2018 IECC Work Group

Agenda

RE: MONTANA ENERGY CODE UPDATE

Re: RECA Comments Supporting Adoption of the 2018 *International Energy Conservation Code* for Residential and Commercial Construction in Montana

Table N1105.5.2 (1) [R405.5.2 (1)]
SPECIFICATIONS FOR THE STANDARD REFERENCE AND PROPOSED DESIGNS

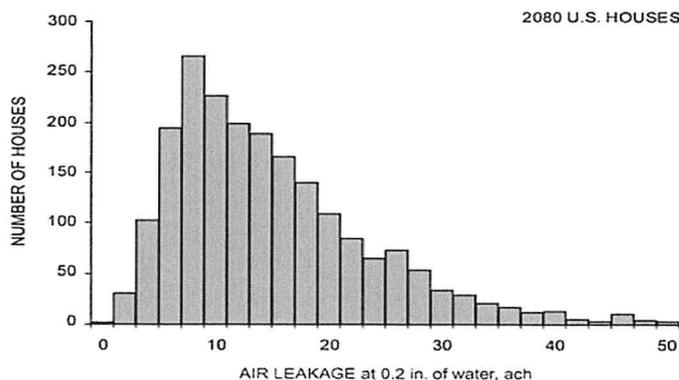
This amendment modifies the requirement from 3 air changes per hour (ACH) to 5 ACH in climate zones 1-8.

Building tightness is an important part of an energy-efficient and comfortable house. However, 3 air changes (ACH) per hour at 50 Pascals is an extremely low target tightness, especially for smaller homes. The ASHRAE Handbook of Fundamentals shows that around 8% of U.S. homes achieve 3 ACH or less, 13% achieve 4 and less than 23% achieve 5. The proposed 5 ACH while still an aggressive tightness level will provide a tight, comfortable, energy-efficient home.

N1102.4.1.2 (R402.4.1.2) Testing. The building or dwelling unit shall be tested and verified as having an air leakage rate of not exceeding five air changes per hour in Climate Zones 1 and 2, and three air changes per hour in Climate Zones 3 through 8. Testing shall be conducted in accordance with RESNET/ICC 380, ASTM E 779 or ASTM E 1827 and reported at a pressure of 0.2 inches w.g. (50 Pascals). Where required by the *code official*, testing shall be conducted by an *approved* third party. A written report of the results of the test shall be signed by the party conducting the test and provided to the *code official*. Testing shall be performed at any time after creation of all penetrations of the *building thermal envelope*.

BUILDING COMPONENT	STANDARD REFERENCE DESIGN	PROPOSED DESIGN
Air exchange rate	<p>Air leakage rate of 5 air changes per hour in Climate Zones 1 and 2, and 3 air changes per hour in Climate Zones 3 through 8 at a pressure of 0.2 inches w.g (50 Pa). The mechanical ventilation rate shall be in addition to the air leakage rate and the same as in the proposed design, but no greater than $0.01 \times CFA + 7.5 \times (Nbr + 1)$</p> <p>where:</p> <p><i>CFA</i> = conditioned floor area</p> <p><i>Nbr</i> = number of bedrooms</p> <p>Energy recovery shall not be assumed for mechanical ventilation.</p>	<p>For residences that are not tested, the same air leakage rate as the standard reference design. For tested residences, the measured air exchange rate^a.</p> <p>The mechanical ventilation rated shall be in addition to the air leakage rate and shall be as proposed.</p>
